# COLLECTIVE AMENDMENTS TO SEVERAL REGULATIONS REGARDING THE COLOUR "SELECTIVE YELLOW"

This informal document addresses those parts of the proposal by Germany (TRANS/WP.29/GRE/2004/52) which concern Regulations Nos. 37 and 99 and which are still relevant for the practical application of these Regulations; it also takes into account the proposal by Japan (TRANS/WP.29/GRE/2004/36).

ECE REGULATION No. 37 – Filaments lamps

# D. DIAGRAM

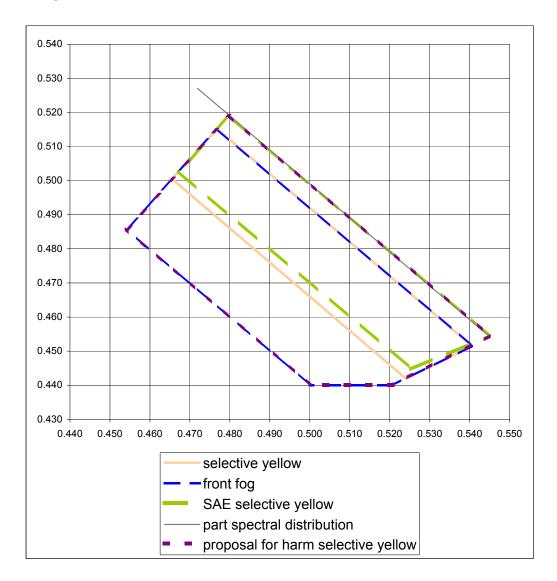
GTB proposed to align all "yellow", "selective yellow", ("enlarged selective yellow" and "selective yellow for front fog"); to rename into "selective yellow" with colour boundaries:

limit towards red  $y \ge 0.138 + 0.580 \text{ x}$ limit towards green  $y \le 1.290 \text{ x} - 0.100$ limit towards white:  $y \ge 0.940 - \text{x}$  and  $y \ge 0.440$

These boundaries comprise all existing boundaries and are equal to the front fog selective yellow but extended to the spectral distribution to allow harmonization with SAE. See diagram below.

"3.9.3. In case of **selective** yellow light, the colorimetric characteristics shall lie within the area formed by the following limits:

limit towards red  $y \ge 0.138 + 0.580 \text{ x}$ limit towards green  $y \le 1.290 \text{ x} - 0.100$ limit towards white:  $y \ge 0.940 - x$  and  $y \ge 0.440$ ."
